Crescent Point

RE: Town of Fox Creek Discussion – Follow-up Questions and Answers

We write to provide Crescent Point Energy Corp.'s ("Crescent Point") responses to questions it received by email dated April 1, 2022, from the Town of Fox Creek following the March 21, 2022, meeting between Crescent Point and the Town to review Crescent Point's proposed drilling operations on or near 09-01-063-19W5 (the "Well Pad"). Below, we have stated each question that the Town asked Crescent Point to respond to, followed by Crescent Point's response to each question.

CPG Traffic Light System –
Town of Fox Creek

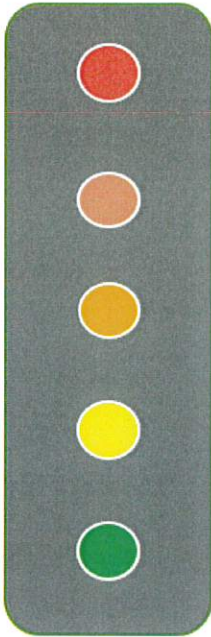
The Town believes that there should be stricter "stop" points on the stop light system. Would Crescent Point be willing to increase the sensitivity? What measures does Crescent Point have in place should a seismic event occur?

- In response to the Town's request, Crescent Point proposes the updated and enhanced stoplight system as described below. Among other things, mitigation measures would include adjustments being made by Crescent Point to the hydraulic fracturing design if a 1.5 magnitude event level is experienced, compared to the AER regulated 2.0. For events above a 3.0 magnitude event level, Crescent Point would respond with other mitigation measures, such as making design changes to avoid further surface disturbances.
